APPLICATION FOR ZONING CHANGE

Date 2-25-91NAME OF PROPOSED DEVELOPMENT Steger Retail AdditionLOCATION OF PROPOSED DEVELOPMENT N.E. corner of FM 740 and
FM 3097NAME OF PROPERTY OWNER/DEVELOPER Estate of O.L. Steger, Jr. and Emily Sue
Whitehead
c/o Lakeside National BankADDRESS P.O. Box 9PHONE (214) 771-8311Rockwall, Texas 75087NAME OF LAND PLANNER/ENGINEER Winkelmann & Associates, Inc.ADDRESS 12800 Hillcrest Road, Suite 200PHONE (214) 490-7090Dallas, Texas 75230TOTAL ACREAGE 4±CURRENT ZONING ANUMBER OF LOTS/UNITS 1PROPOSED USE FOR DEVELOPMENT Grocery Store

FOOD LION, INC. SITE #50a
F.M. 740 @ F.M. 3097
Rockwall County
Rockwall, Texas

I have reviewed the preliminary information that has been submitted in conjunction with this request. Additionally, the Planning and Zoning Commission reviewed the plans in their last worksession and our comments regarding the proposed development are as follows:

JOB NO.	06416.01
DATE	2-18-91
DRAWN	A.J.L./A.L.C.
CHK.	M.D.C.
DISC.	6416Site.Dwg
SHEET OF	1 of 1
LANDSCAPE PLAN

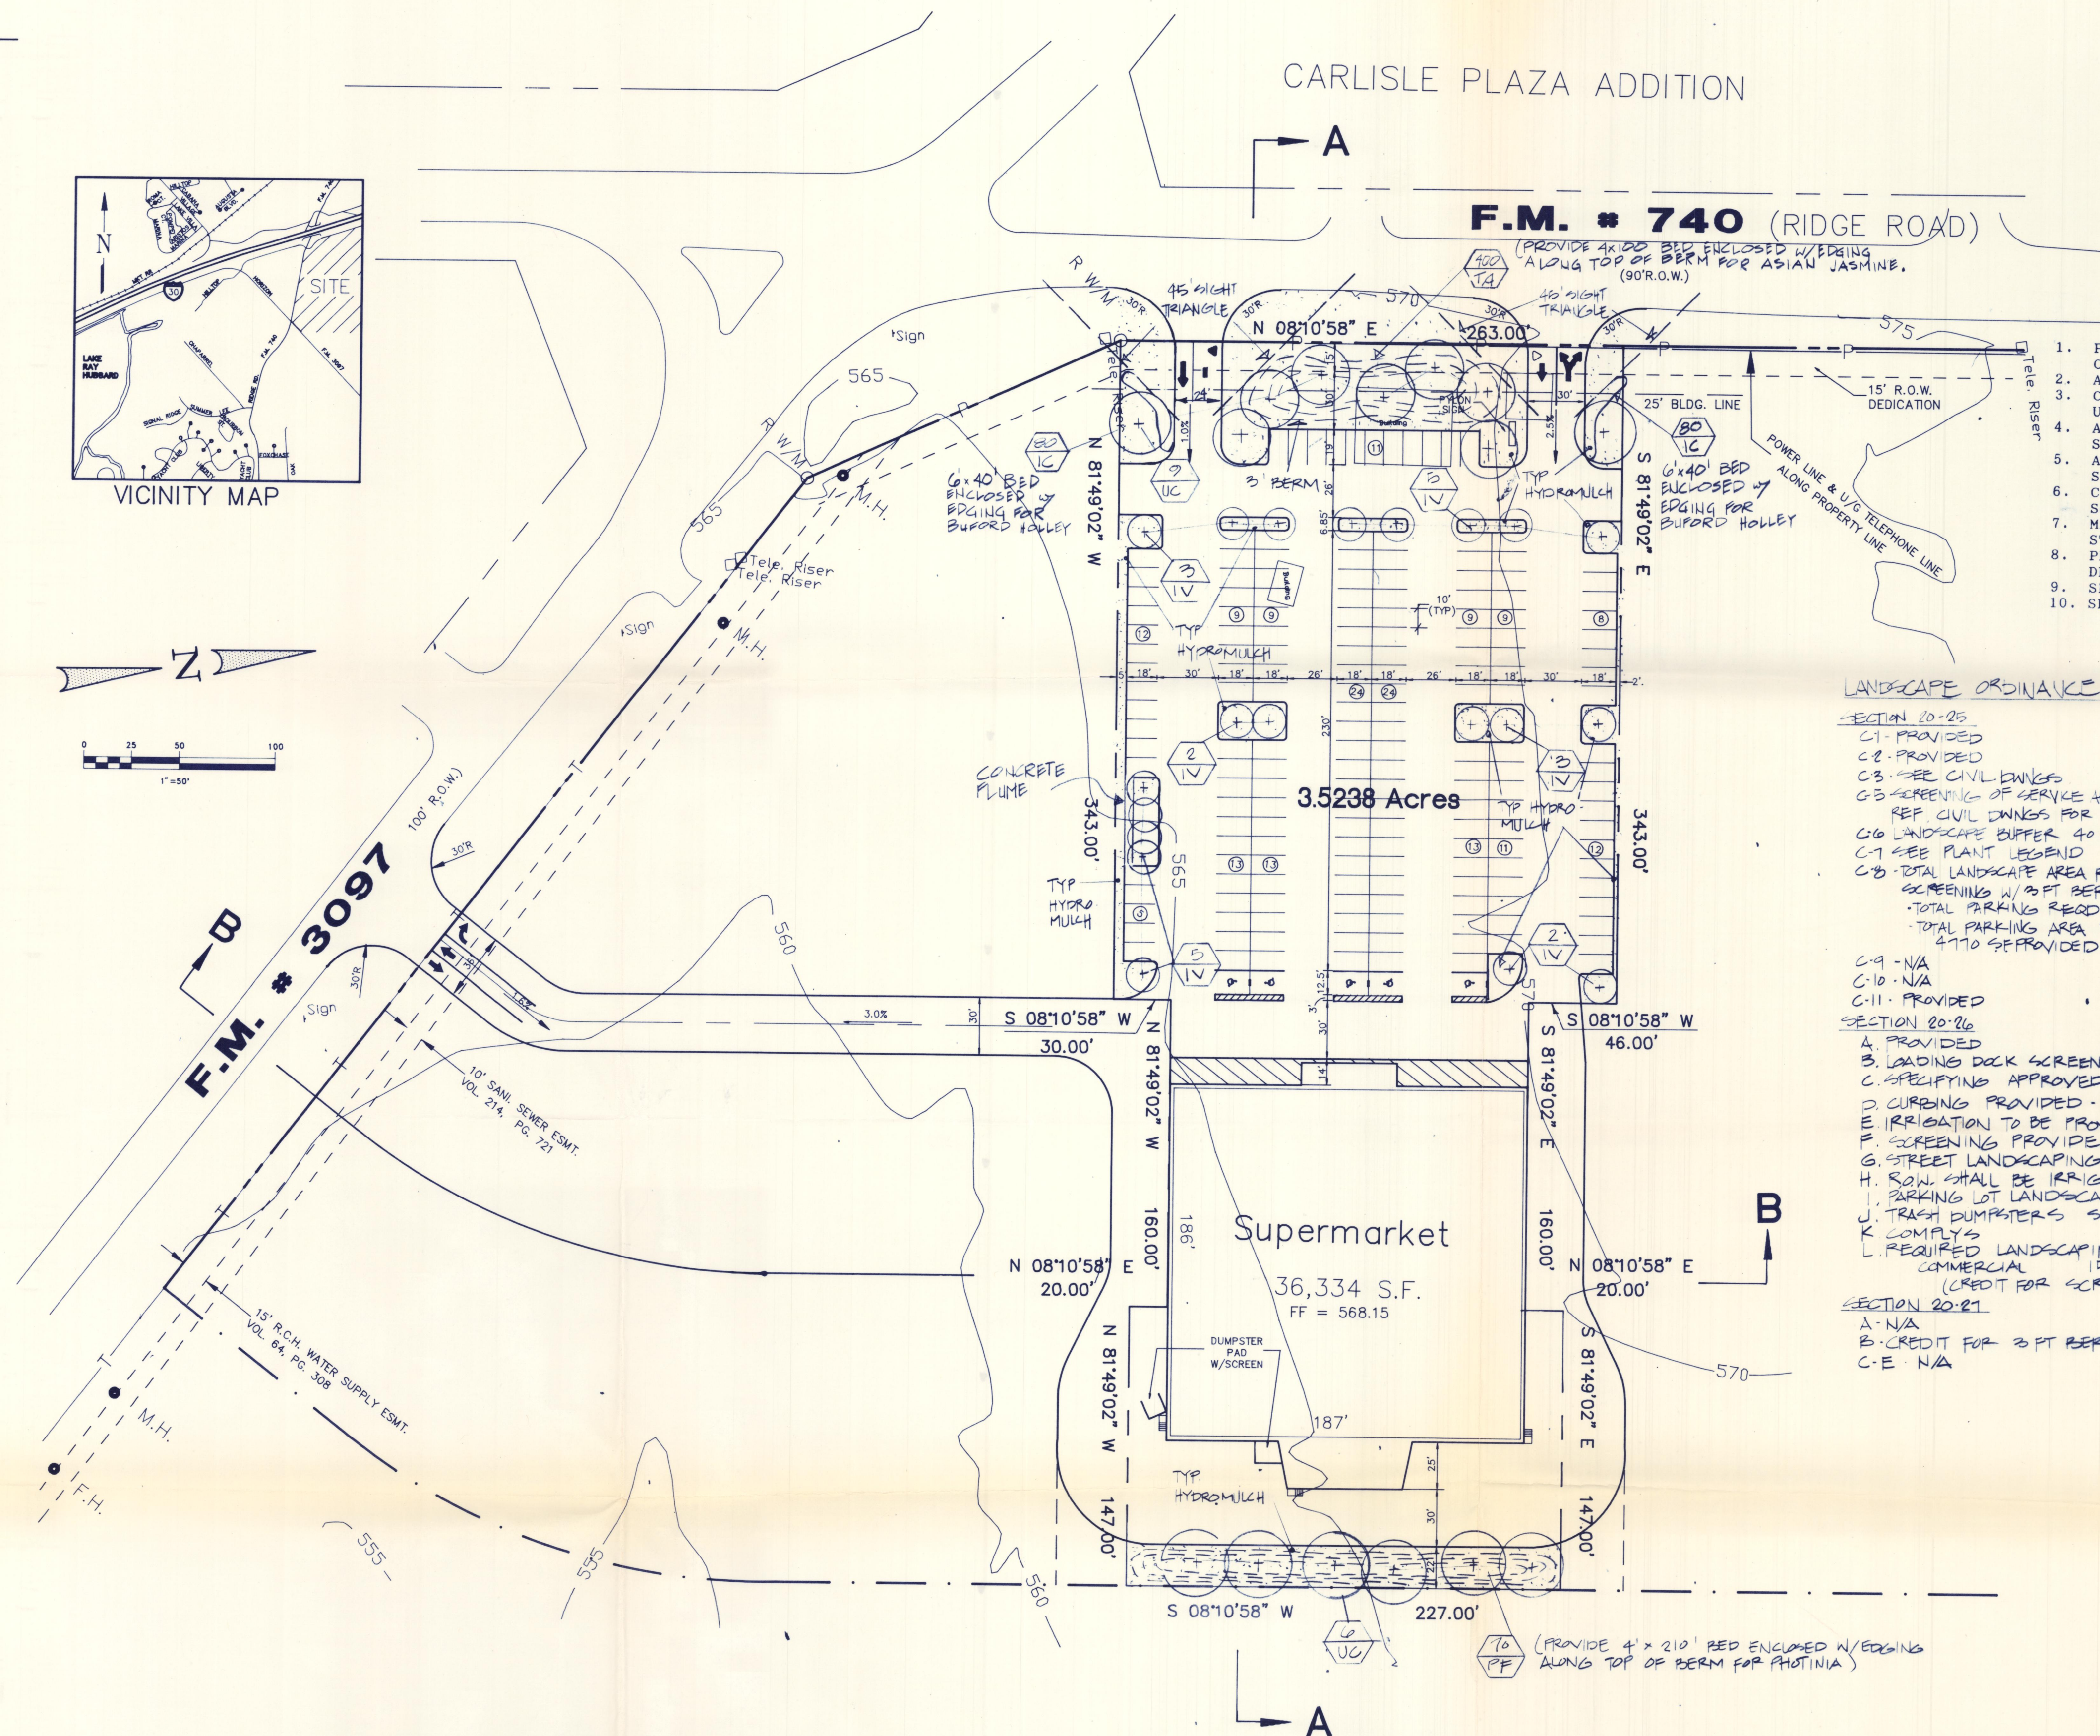
Get strip of landscaping down middle of get credit - add trees in center & change all to large trees
 drive are too close per requirements
 need shrubs on either side of drive
 install a canopy in front of bldg.

need to add 2 more trees in street

1. The total site requirement for landscaping is 18,708 sq. ft. In reviewing the plan I find approximately 16,600 sq. ft. Please identify the area of the individual landscaped areas. The area to be dedicated as ROW for FM-740 cannot be included in the calculation. I would recommend that you consider including an 8 foot strip between the two center parking stalls. This would provide the additional landscaping area and would enhance the parking lot.
2. You have reduced the percentage of required landscaping by including a 3 ft. berm in the front of the tract. Please identify what landscaping will be planted on

the berm in addition to the required street trees. I would encourage some low maintenance ground cover or low shrubs along the top of the berm. You will need to add 3 foot evergreen shrubs in front of the parking lot on either side of each entrance to fully gain this credit.

4. You need to add 2 more trees along the frontage. In the Overlay District the ratio is one tree per each 30 feet of frontage.
5. You are showing 17 yaupon holly trees internal to the parking lot. These are classified as small trees under our landscaping ordinance. The ordinance provides that one large tree per every 20 parking spaces be provided. This may be considered an equivalent exchange by the Commission, which will be discussion at the meeting.

JOB NO.	06416.01
DATE	2-18-91
DRAWN	A.J.L./A.L.C.
CHK.	M.D.C.
DISC.	6416Site.Dwg
SHEET OF	1 of 1
SITE PLAN

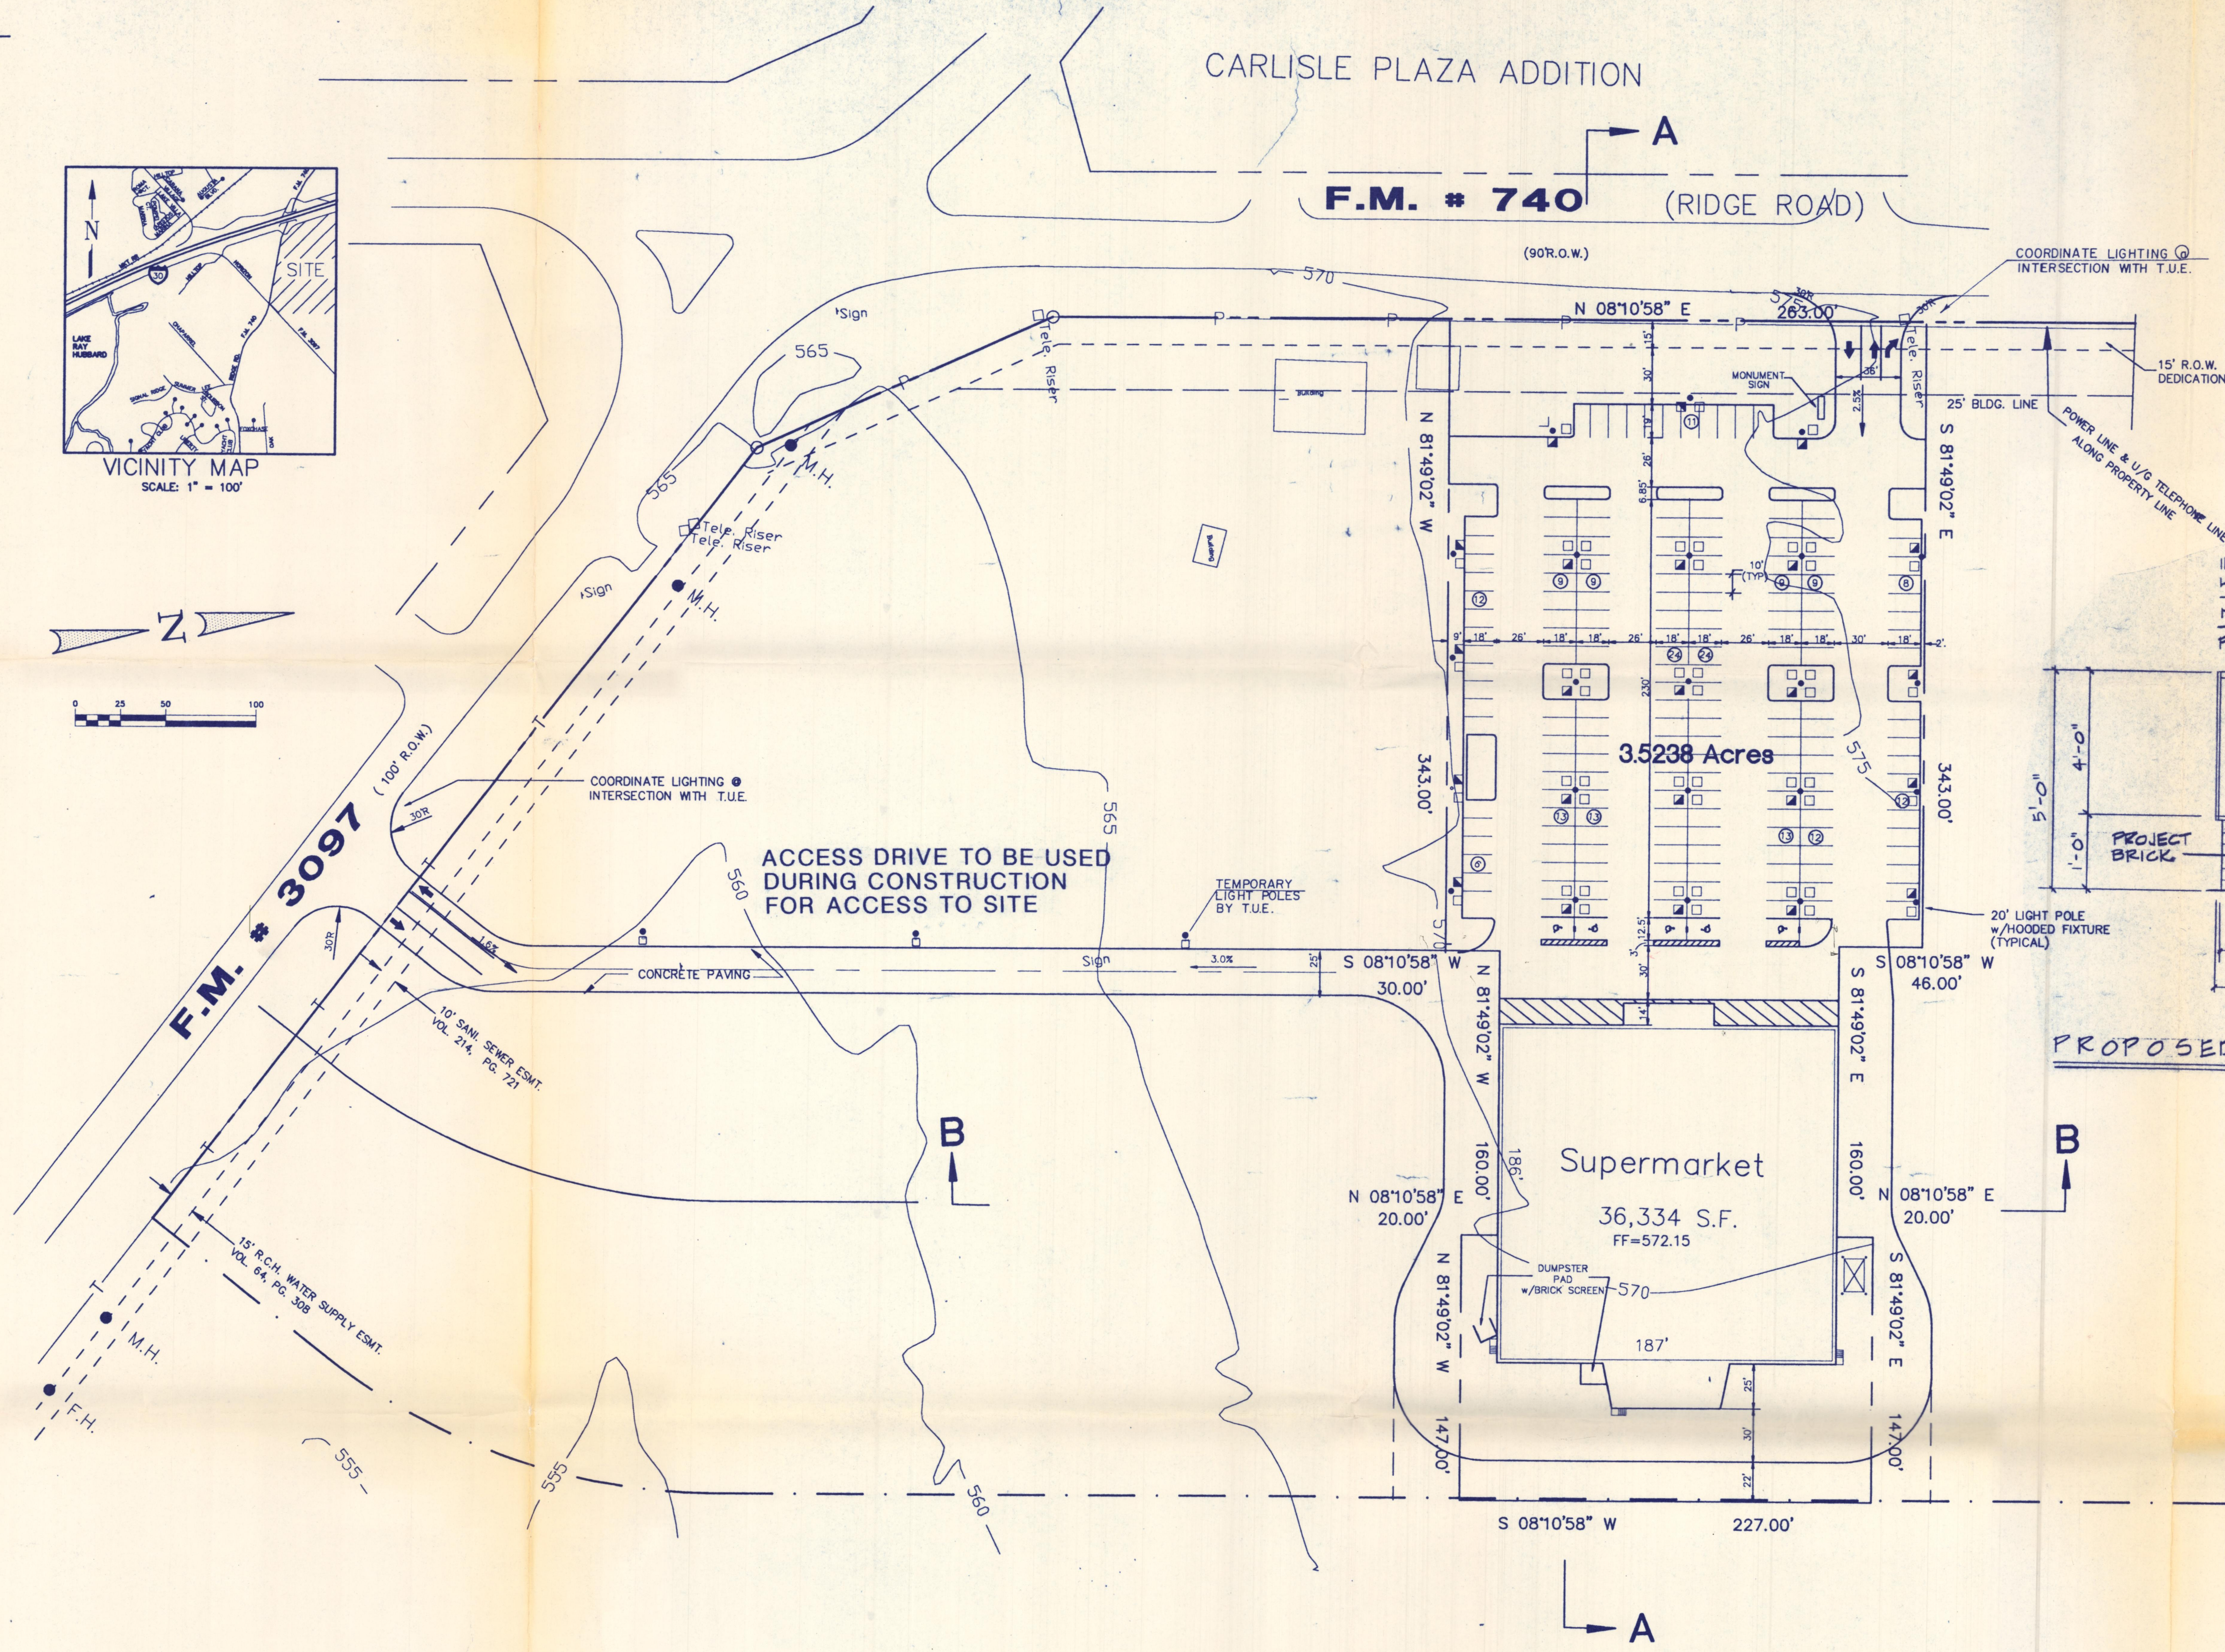
need to show how lane expansion in site plan.

1. The plan proposes two drives on FM-740 that are approximately 160 feet apart. The minimum separation for drives along an arterial is 200 feet. The Commission

and Council have the ability to waive this requirement if it is determined to be in the interest of the City. The Commission and staff have some concern about the proximity of the southern drive to FM-3097. Given this concern and the fact that the drives do not meet separation standards you will need to either amend the plan to eliminate the southern drive or present your reasons for wanting the two drives. The original plan proposed for Food Lion to the south of this location did not propose two drives on FM-740.

3. There was some concern about the throat length of the entrance(s). I am having John Reglin review this issue.
4. As you are aware a turn lane does need to be provided for the entrance off of FM-740. From preliminary discussions with Mr. Reglin it appears that the existing turn lane for the shopping center can be added onto to meet the needs of your turn lane. You need to submit a schematic of what you propose to do to address the turn lane.

5. You need to submit details for the parking lot lighting. The previous site plan was restricted to light poles not exceeding 20 feet in height with hooded fixtures to direct the glare. Please indicate the type and height of lighting proposed.

1. All easements have been added to this drawing.
2. A future 10' R.O.W. dedication has been shown for FM 3097.
3. As discussed, we have modified the R.O.W. on the major thoroughfare to be 110' wide.
- * 4. Driveway locations have been noted.
- * 5. A note stating that a reciprocal easement agreement will be established for Lots 1, 2 & 3 has been added.
